Memorandum to the City of Markham Committee of Adjustment

File: A/085/22
Address: 9 Hughson Drive, Markham
Applicant: Tim Huang
Agent: Tim Huang
Hearing Date: Wednesday September 21, 2022

The following comments are provided on behalf of the Central Team.

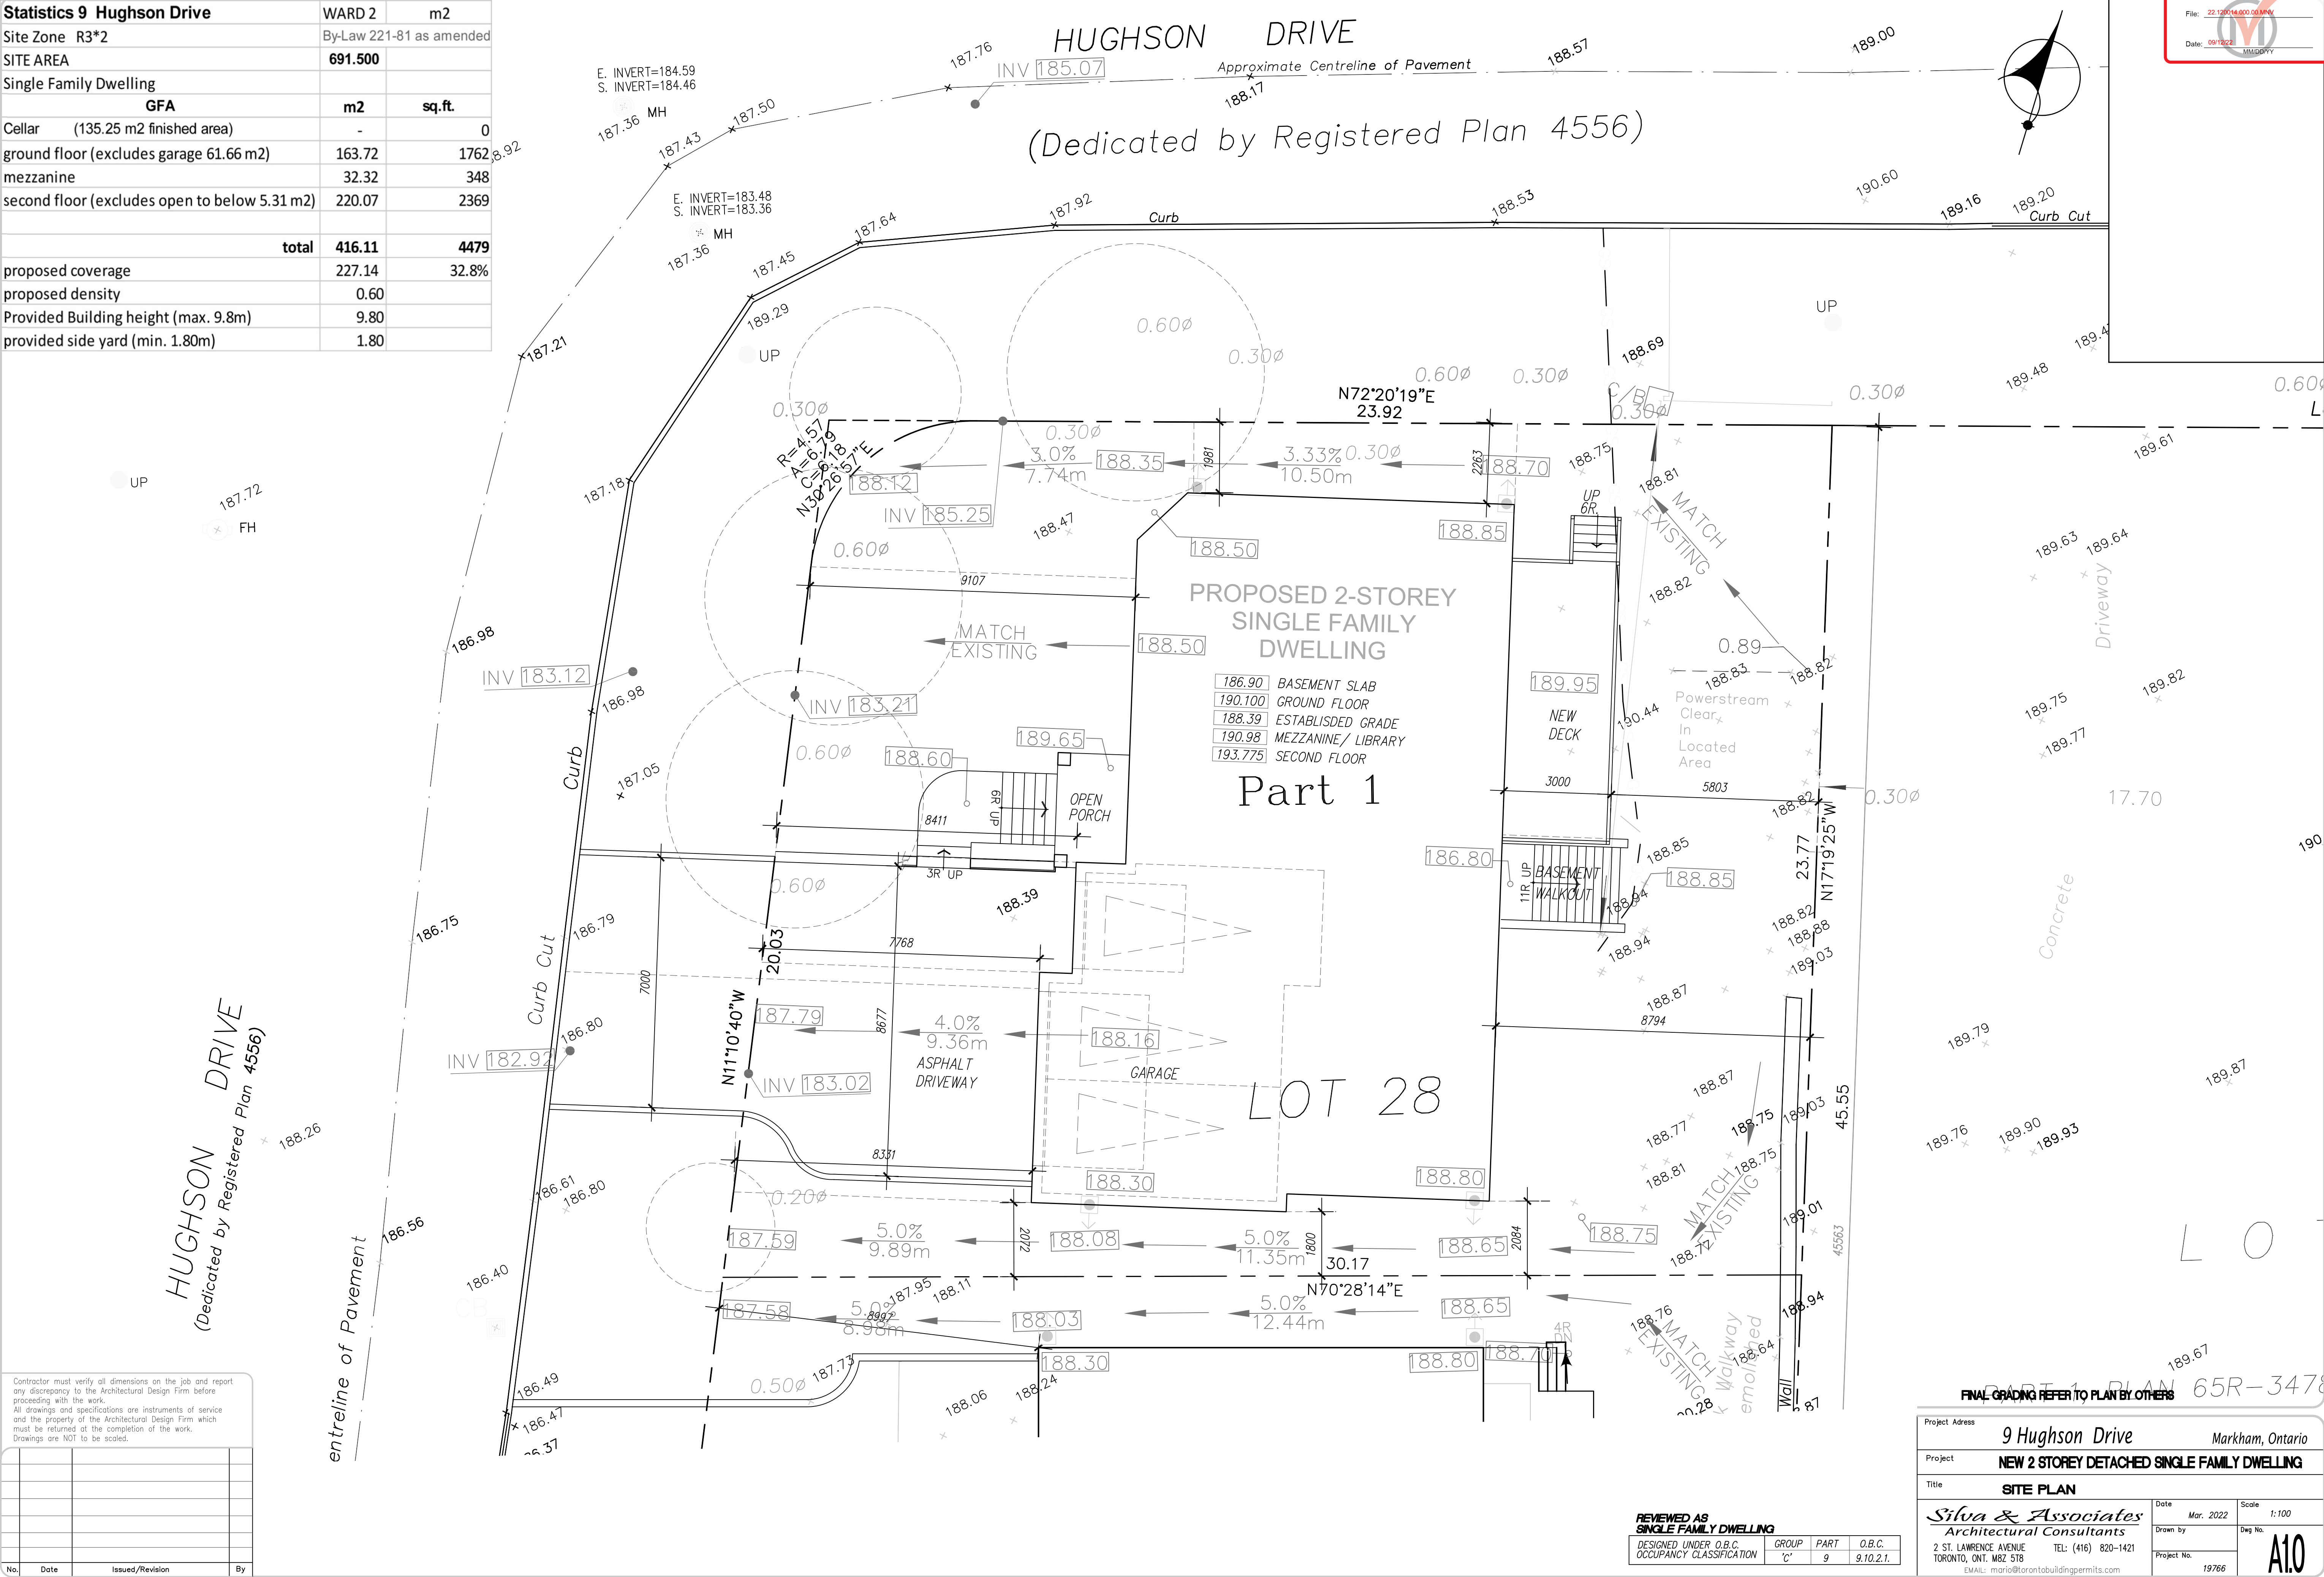
The subject lands are irregular in shape, and are narrower on the north side of the property (exterior side yard) than the south side (interior side yard), (refer to the site plan in Appendix “B” – Plans). The alignment of the proposed dwelling results in an irregular front yard setback, with the shortest distance being 7.7 m (25.26 ft), which applies to a portion of the garage.

As noted previously, the subject lands are irregular in shape (refer to the site plan in Appendix “B” – Plans). The alignment of the proposed dwelling results in an exterior side yard setback that ranges between 1.9 m (6.23 ft) and 2.2 m (7.21 ft).

Staff have no objections to the requested variance, and are of the opinion that the general intent and purpose of the Zoning By-law is maintained.

Staff are of the opinion that the proposed exterior yard setback is minor and have no concern with the requested variance.

BUILDING SECTION 1 1:50

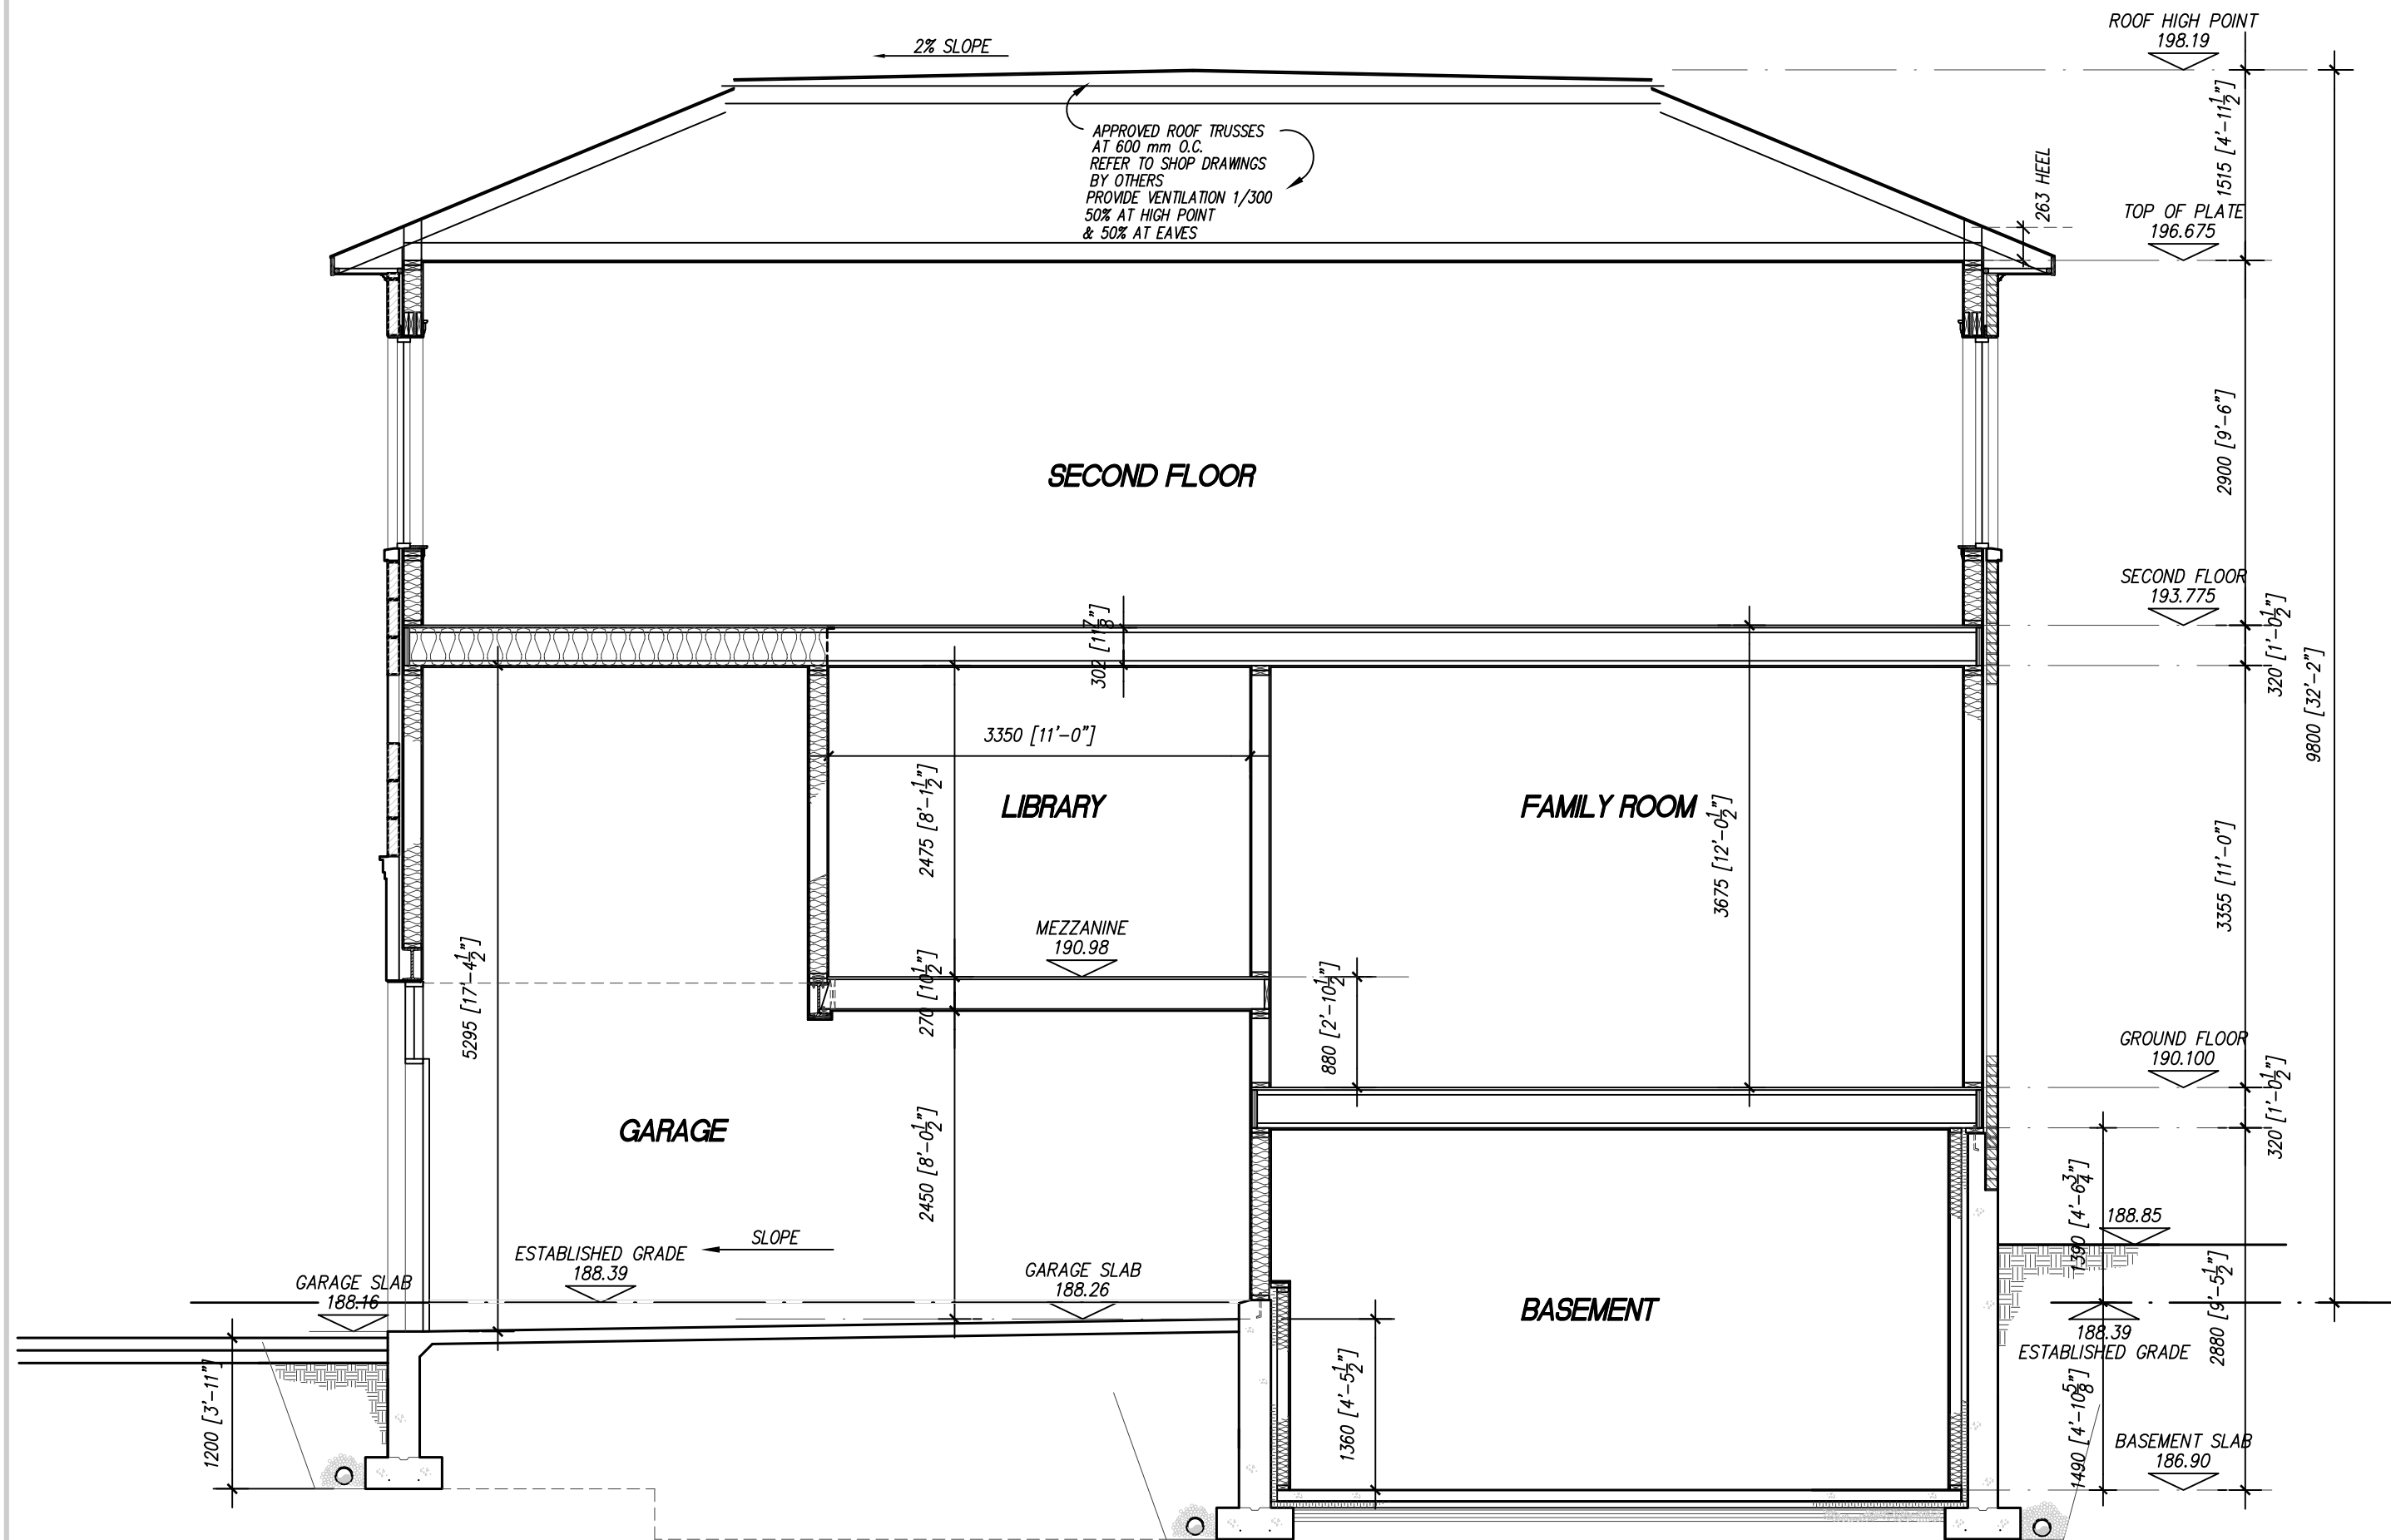
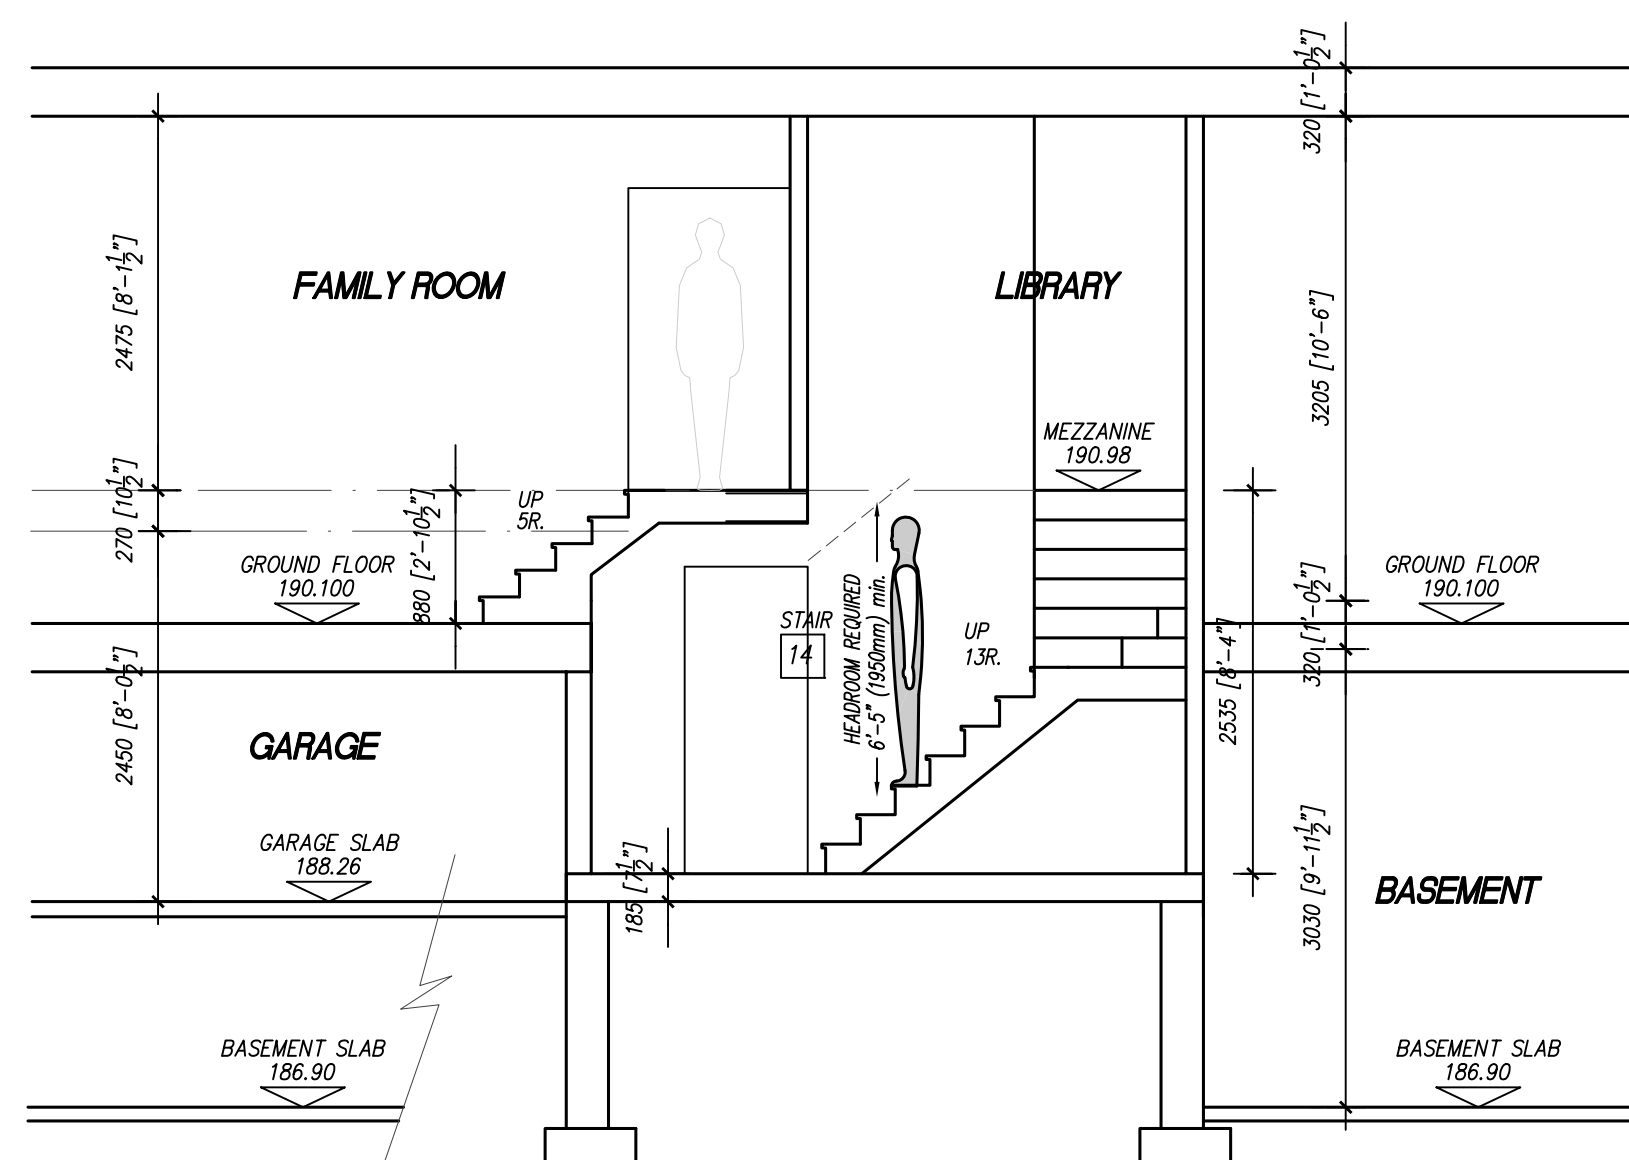
Staff note that the proposed lowest level of the dwelling is located above-grade, and falls within the definition of “basement” rather than a cellar. The proposed above-grade basement is therefore counted as an additional storey.

Staff further note that the proposed dwelling height of 9.8 m (32.15 ft) complies with the maximum height requirement, as set out in the Amending By-law, which is 9.8 m (32.15 ft). As such, Staff have no concerns with the requested variance.
